Microsemi Corporation

Product/Process Change Notification No: PCN17005A

Subject: Important Changes in SmartFusion2 and IGLOO2 Devices

Addendum A: Clarification of CAN 17005.1 Tri-stated I/Os and title update on PCN 17005.2 Table 2 Worst Case Delays by Device Density.

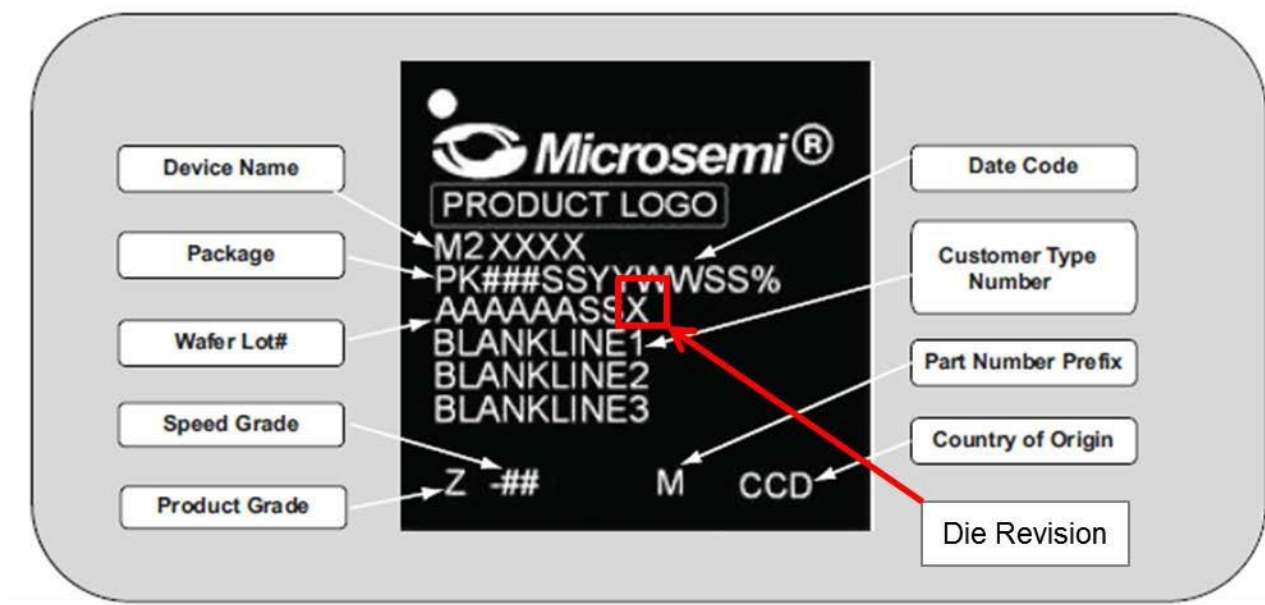
In both SmartFusion2 and IGLOO2 050 device densities, for die revisions 0 and 1, you can write to eNVM pages at addresses 0x6003FC80-0x6003FFFF. This area is reserved for storing the device certificate and digest information. Die revision 2 and above prevent the user from overwriting the device certificate and digest information. Firmware drivers and documentation have been updated to indicate proper usage.

In both SmartFusion2 and IGLOO2 005 and 010 device densities, for die revisions 0, you can write to eNVM pages at addresses 0x6003FC80-0x6003FFFF. This area is reserved for storing the device certificate and digest information. Die revision 1 and above prevent the user from overwriting the device certificate and digest information. Firmware drivers and documentation have been updated to indicate proper usage.

The following figure illustrates the part marking specification for determining the die revision.

If you use eNVM at addresses, 0x6003FC80-0x6003FFFF, on the affected 005, 010, or 050 dies, you must move your data to another region in eNVM. You need to use the latest firmware drivers for writing to the eNVM.
